CHARLOTTE HISTORIC DISTRICT COMMISSION
CERTIFICATE OF APPROPRIATENESS - AMENDED

CERTIFICATE NUMBER: 2016-131

ADDRESS OF PROPERTY: 1319 Thomas Avenue

Rear Yard Shed Plan
 for
 1319 Thomas Ave

PROPOSED DOUBLE SHED PLAN

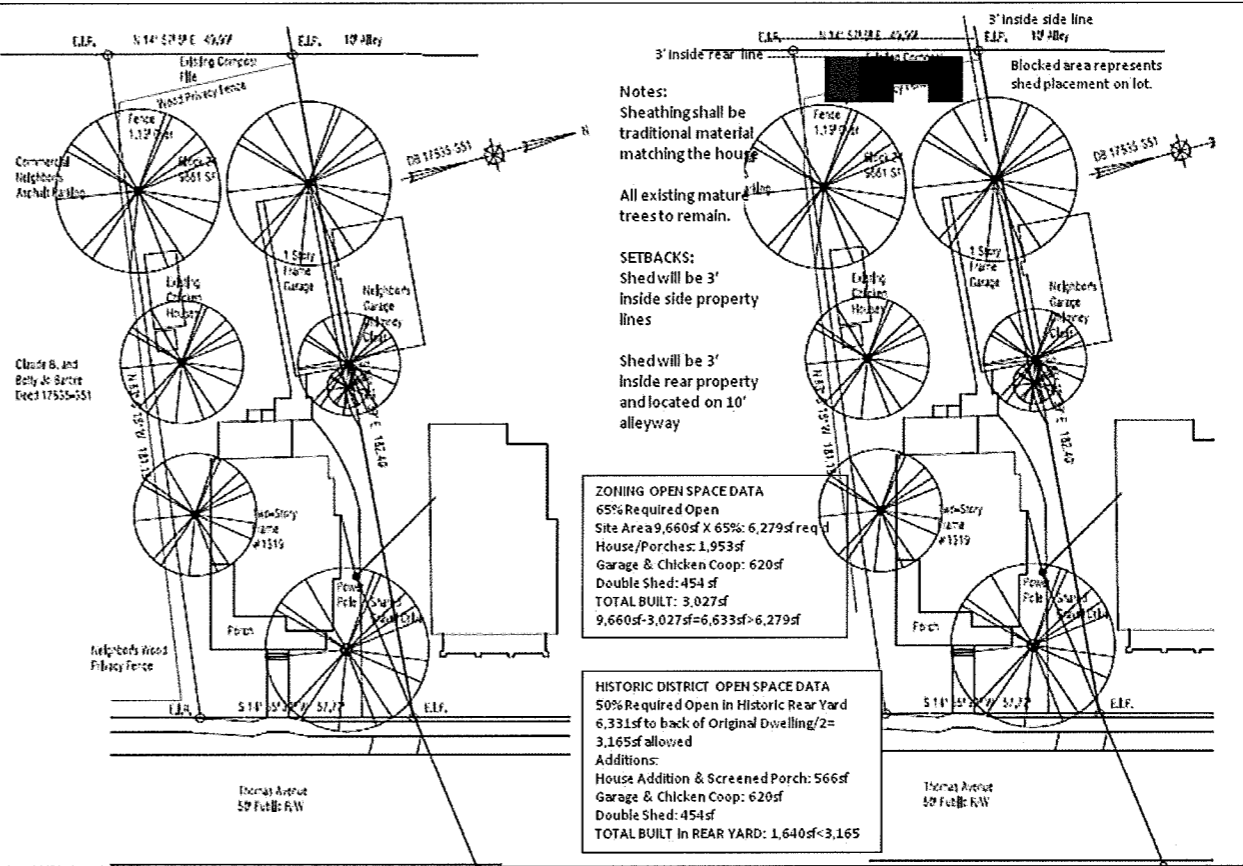
Idea Image:
 Differences: shortened height and reduced dimensions on 'sheds', breezeway 10' wide, no transom over door, roof vent to match house, single step without railings.

South Side

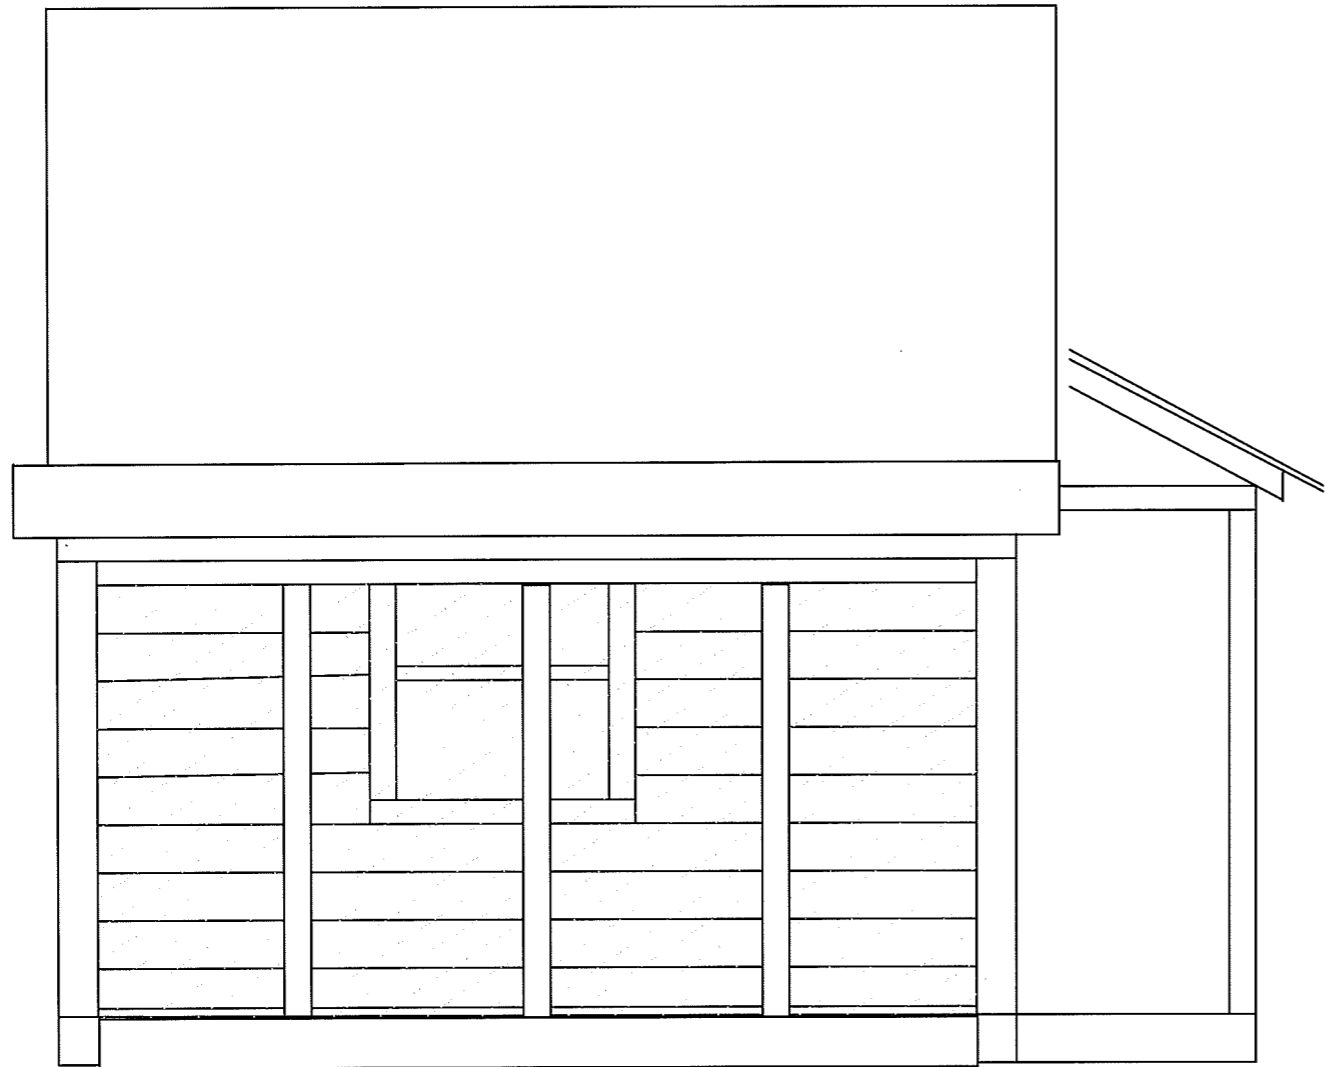
Remove overhang in
 rear on both sheds to
 correct setback on
 North building. Add
 fascia board and little
 dressing (roof lip).

Screened area roofline
 within setback
 requirements. Rear
 overhang may stay as
 is or be removed.

North Side

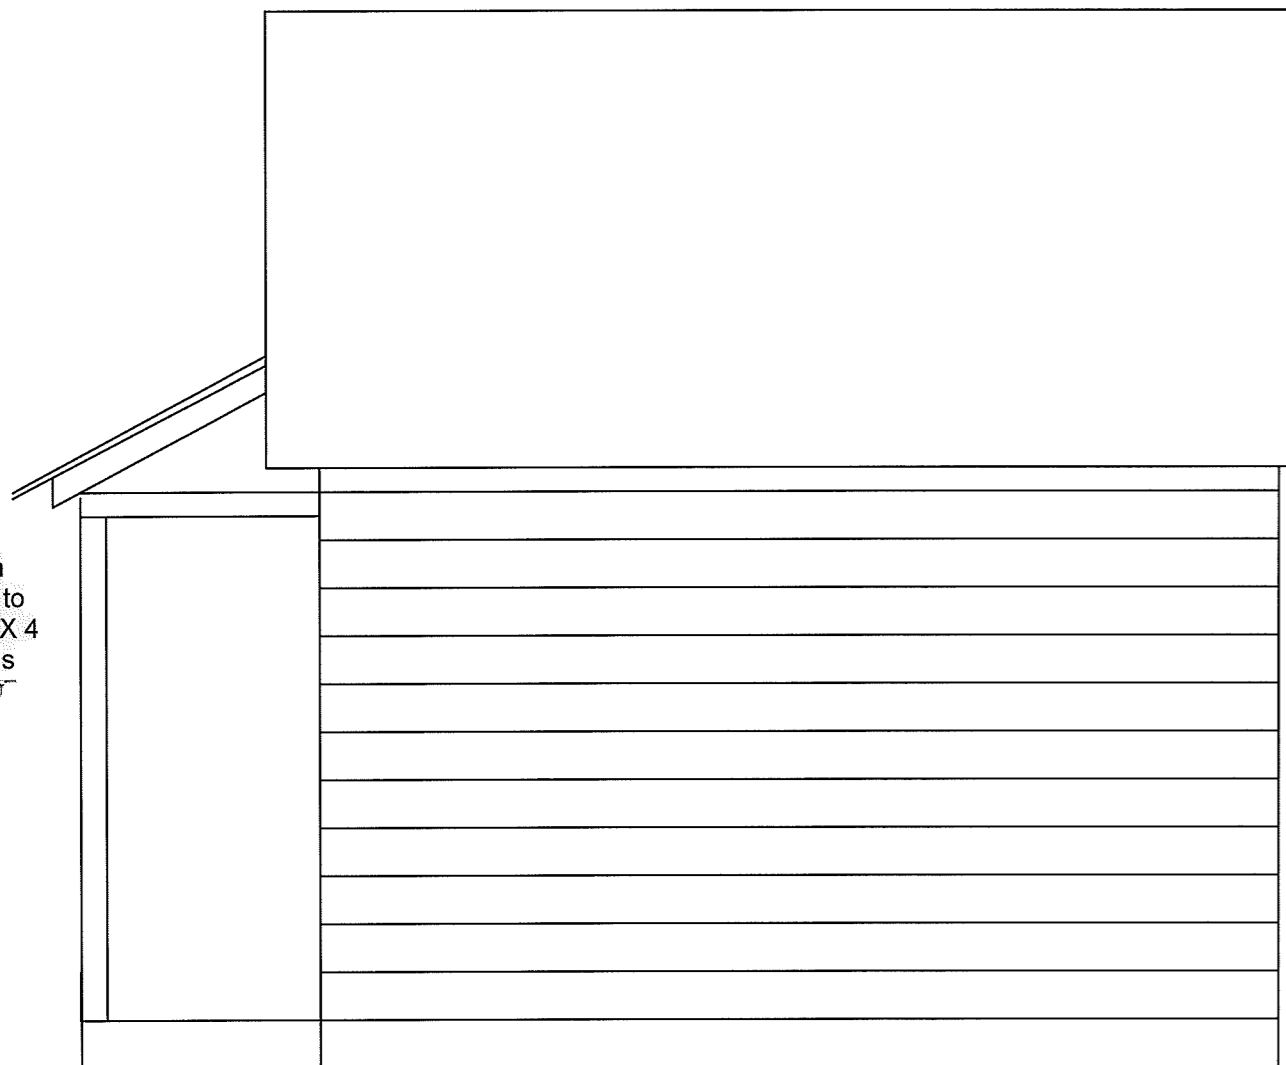
Remove overhang in
rear on both sheds to
correct setback on
North building. Add
fascia board and little
dressing (roof lip).

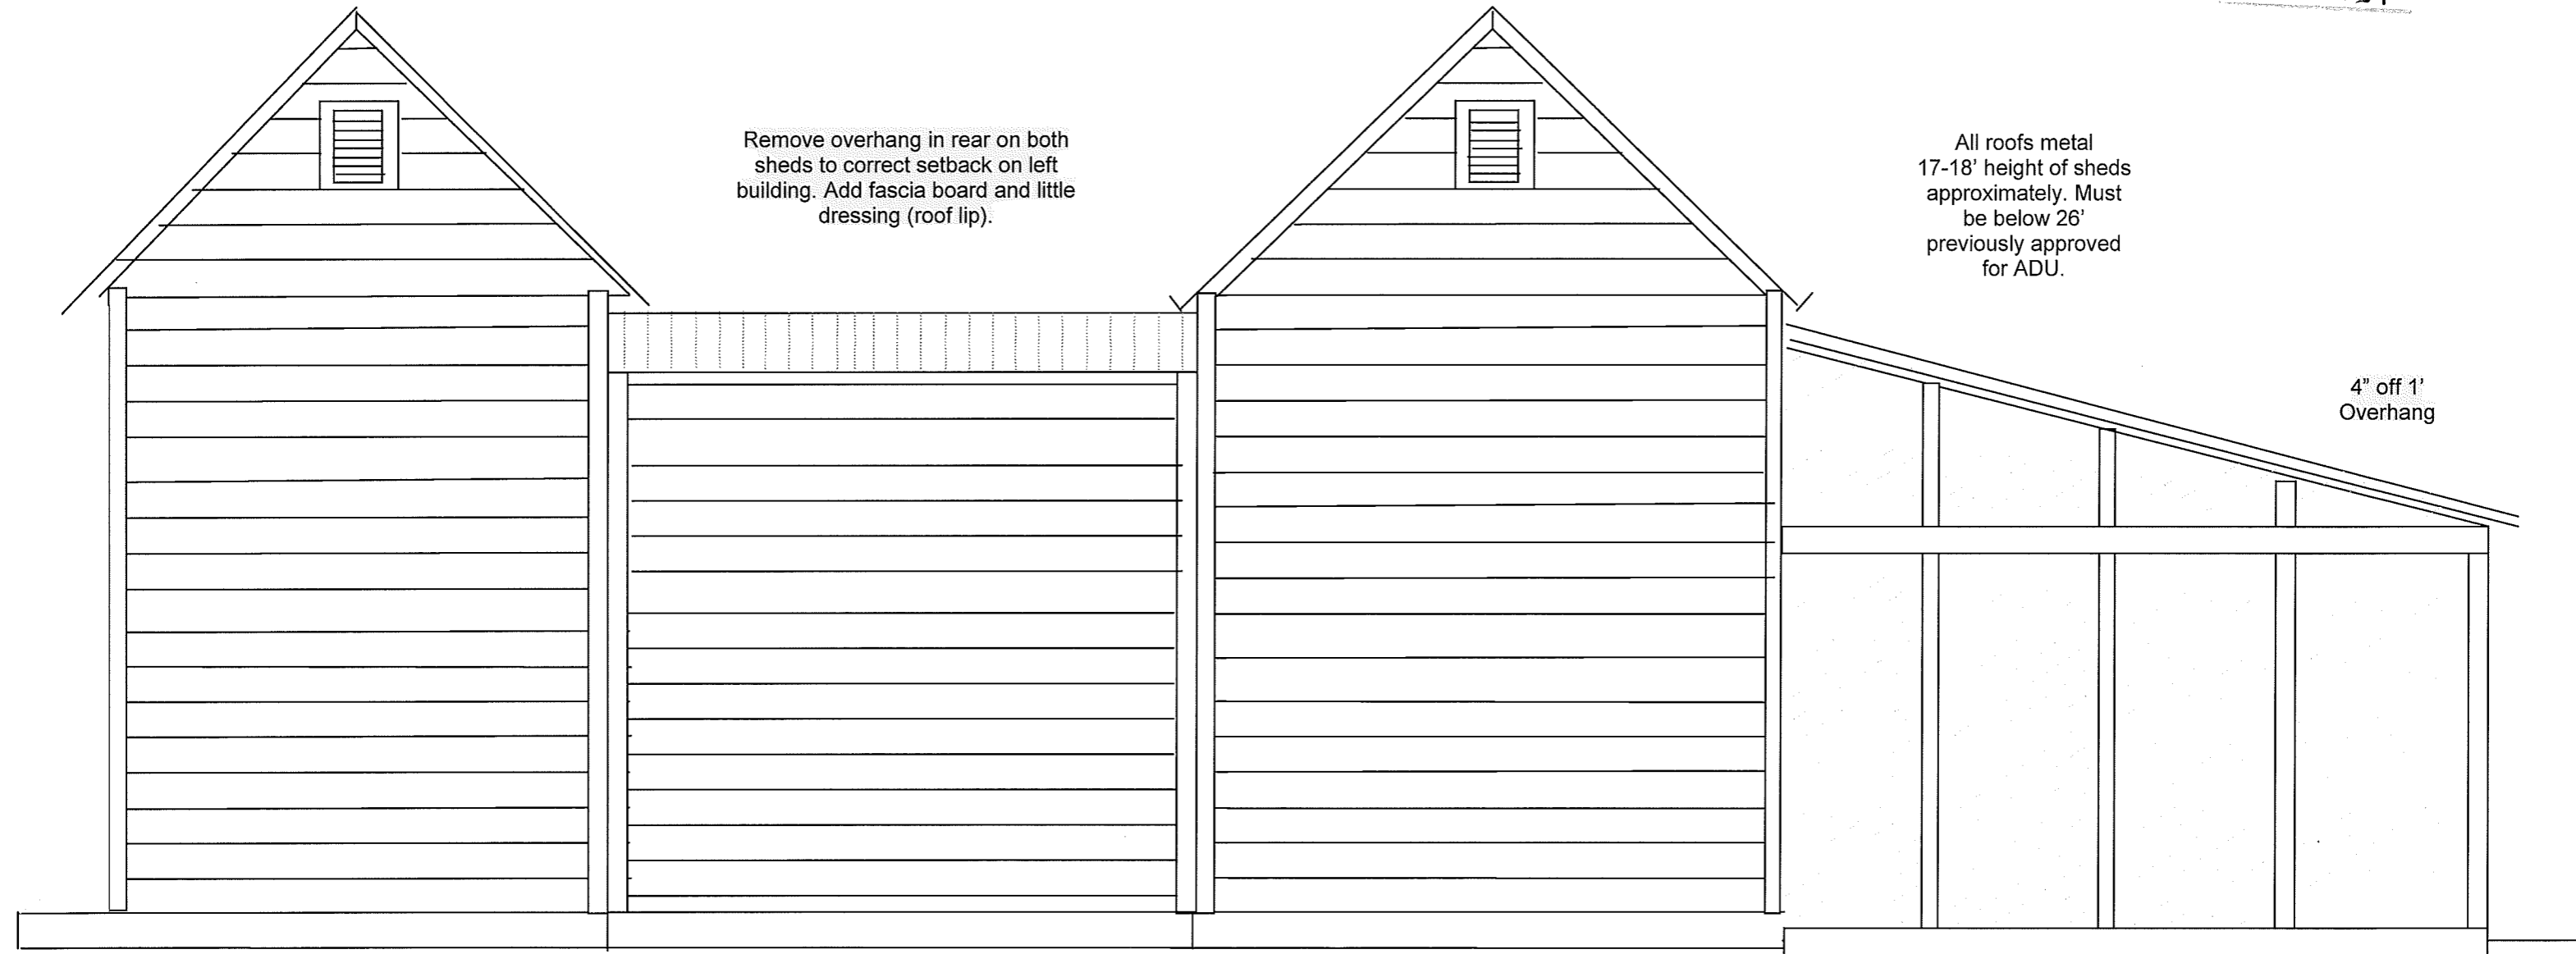
Remove overhang in rear on both sheds to correct setback on left building. Add fascia board and little dressing (roof lip).

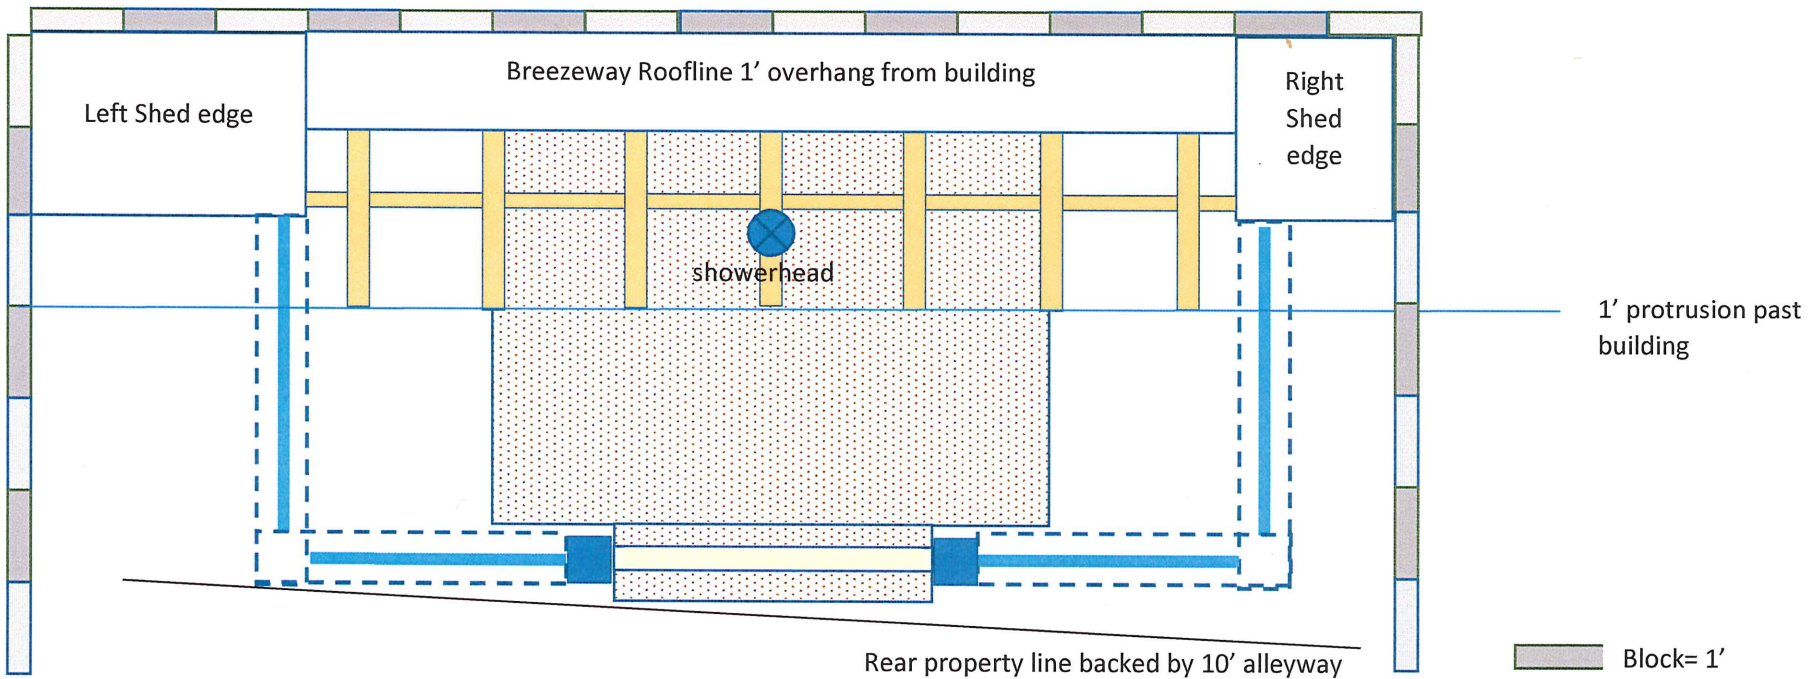
Original shed rear roofline with survey:
Indicates inside corner of 1' roofline was within 3' setback.
Garden trellis rails could protrude 1' past building and to allow for 3' setback to rear property line at most narrow point
